**STAFF REPORT
TO THE FOUNTAIN INN PLANNING COMMISSION
FROM THE PLANNING & DEVELOPMENT DEPT.
December 5, 2022**

DOCKET NUMBER: FI 2022-041

**STAFF REPORT
TO THE FOUNTAIN INN PLANNING COMMISSION
FROM FOUNTAIN INN PLANNING & ZONING STAFF
December 5, 2022**

DOCKET NUMBER: FI-2022-39

STAKEOUT PLAN

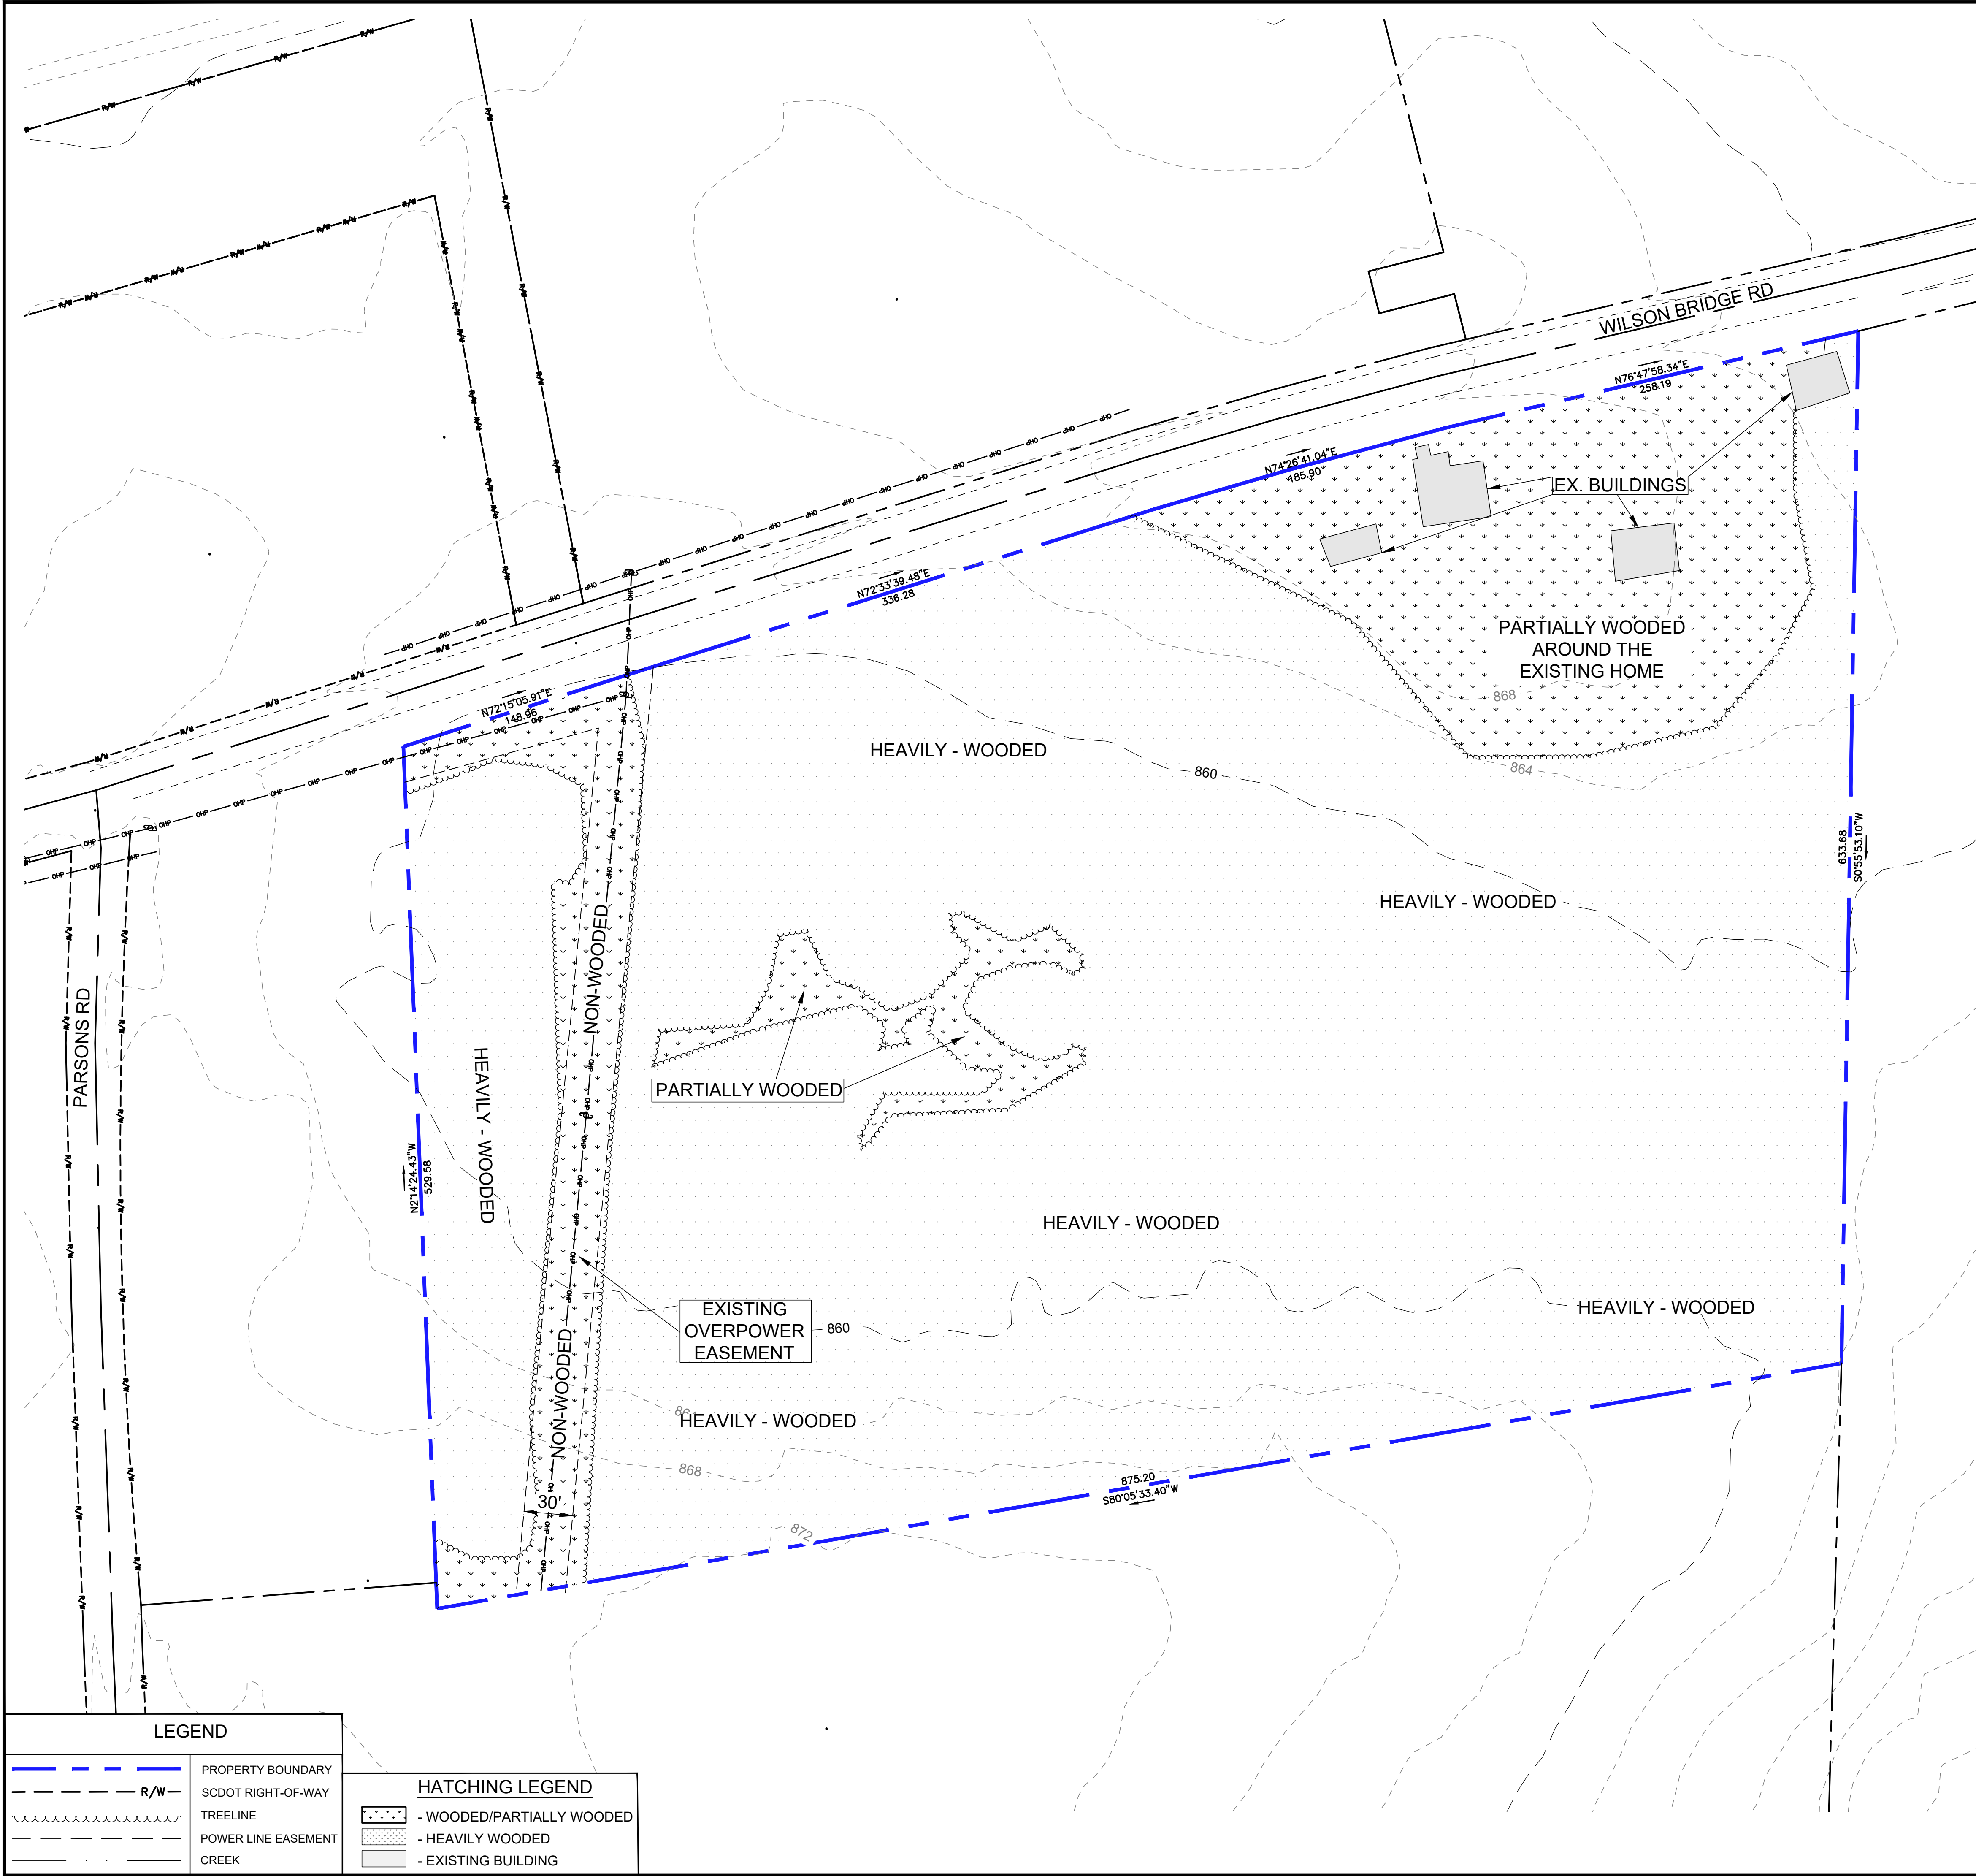
The applicant Mr. Mancero has proposed 172 apartment units in eight buildings. A previous application also called Garden Apartments was requested in November of 2021 with 216 units. Two ingress/egress points would be on Wilson Bridge Road. Two parking spaces per unit are proposed; typically one space per bedroom is required in R-M zoning. Additionally, the proposed density is 14.5 units per acre for the total site, according to the submitted Statement of Intent. 14.5 u/ac is the maximum allowable under the zoning code (R-M). Please see attached Exhibits for more details on the proposal. Minimum lot width, minimum yard sizes, maximum lot coverage, and maximum height are not otherwise regulated within the FRD district provided, however, that the Planning Commission and City Council shall ascertain that the characteristics of building location shall be appropriate as related to structures within the district and otherwise fulfill the intent of this article.

The applicant is requesting a Flexible Review District. High Density Residential is equivalent to any multi-family zoning district (up to 14.5 units per acre); the request and site plan exceeds even this definition under the 2017 Fountain Inn Master Plan

Zoning FRD, Flexible Review District with the number of units proposed would not be consistent with the Future Land Use Map.

The site plan proposing one building type, one housing type (apartments), and no demonstrated inventive design would not be consistent with the zoning intent of the FRD district category.

Annexation can be supported along Wilson Bridge Road due to adjacent or proximate parcels already within the City of Fountain Inn. FRD zoning can also be supported based on proximity to Wexford Park FRD. ~~However, the densities should not exceed standards and~~ design must be unique and inventive with a variety housing types and common area features.

Denial.
